WCAP-14575-A

# **Aging Management Evaluation for Class 1 Piping and Associated Pressure Boundary Components**

November 8, 2000

SUBJECT: ACCEPTANCE FOR REFERENCE IN THE GENERIC LICENSE RENEWAL  
PROGRAM TOPICAL REPORT ENTITLED, "LICENSE RENEWAL EVALUATION:  
AGING MANAGEMENT FOR CLASS I PIPING AND ASSOCIATED PRESSURE  
BOUNDARY COMPONENTS," WCAP-14575, REVISION 1, AUGUST 1996

**Figure 4-1 Flow Chart for Fatigue, AMP-3.3 (for ASME designs) [Ref. 42]**

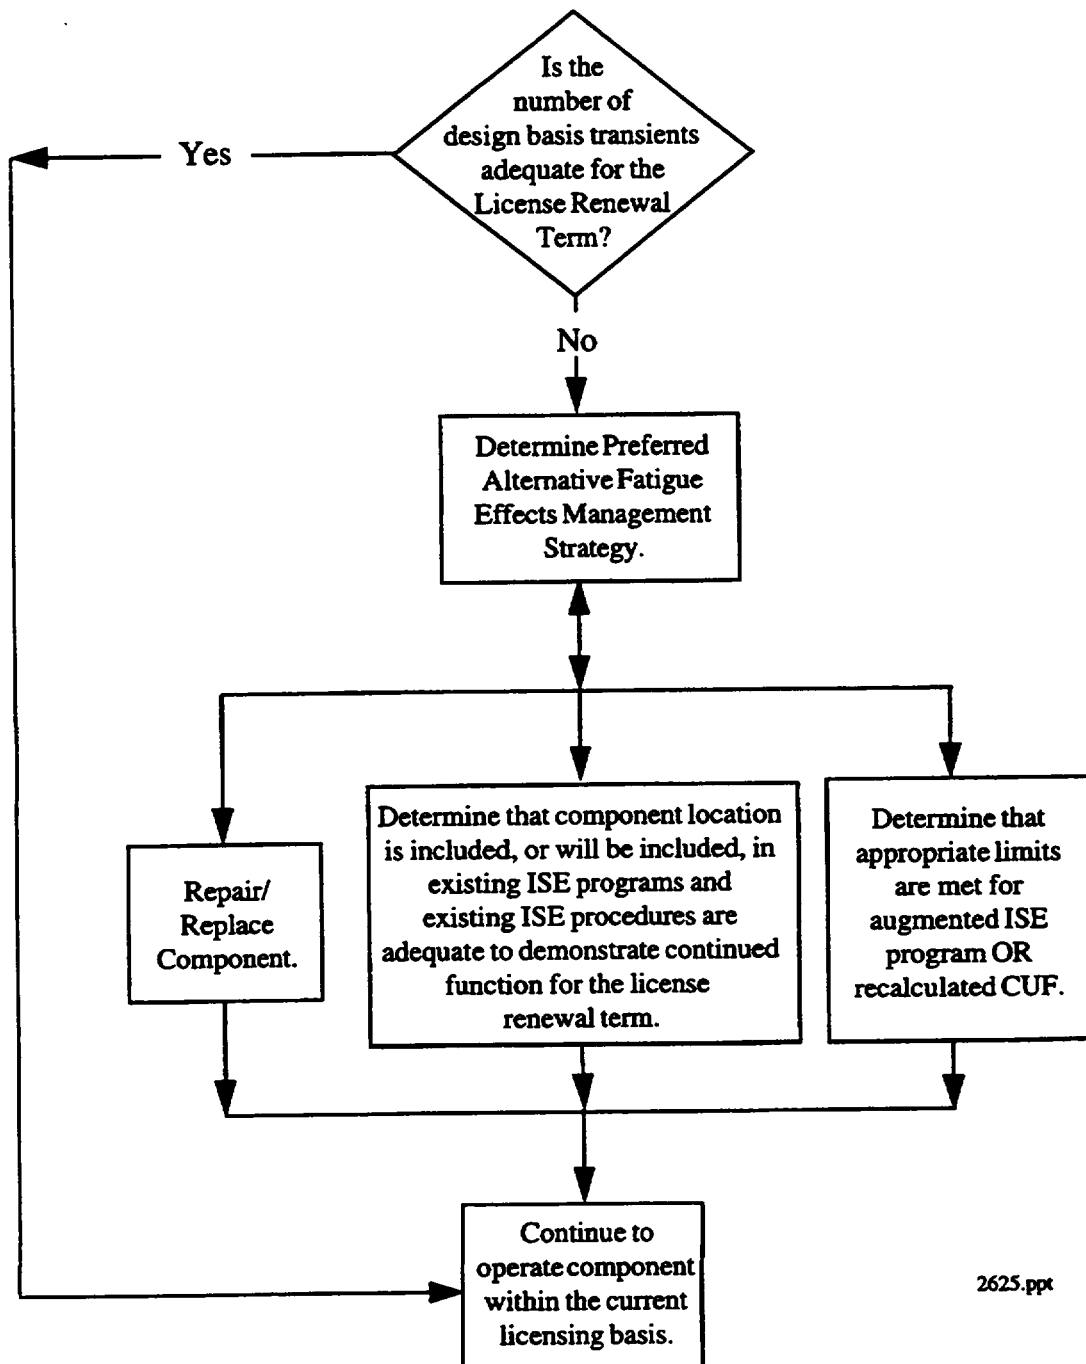
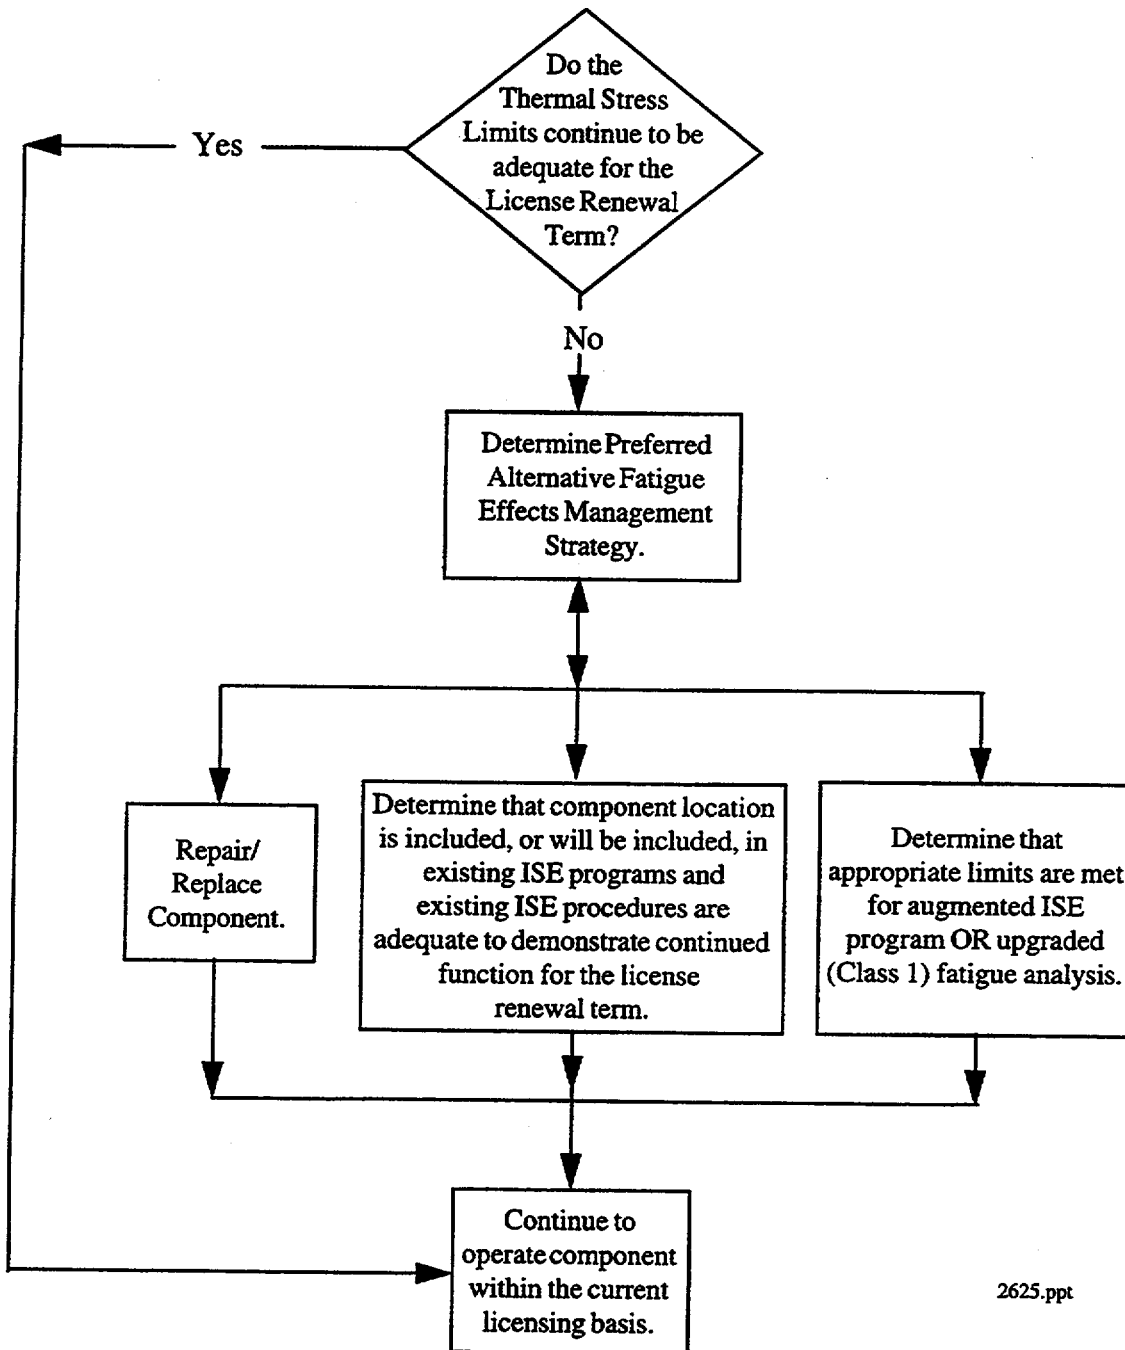
The appropriate changes to sections 3.3, 3.4, 4.2.1, Tables 3-2 thru 3-16, 4-4, 4-5, 4-6, and 4-7, and Figures 4-1 and 4-2 will be made to incorporate the revised industry position that considers environmental effects.
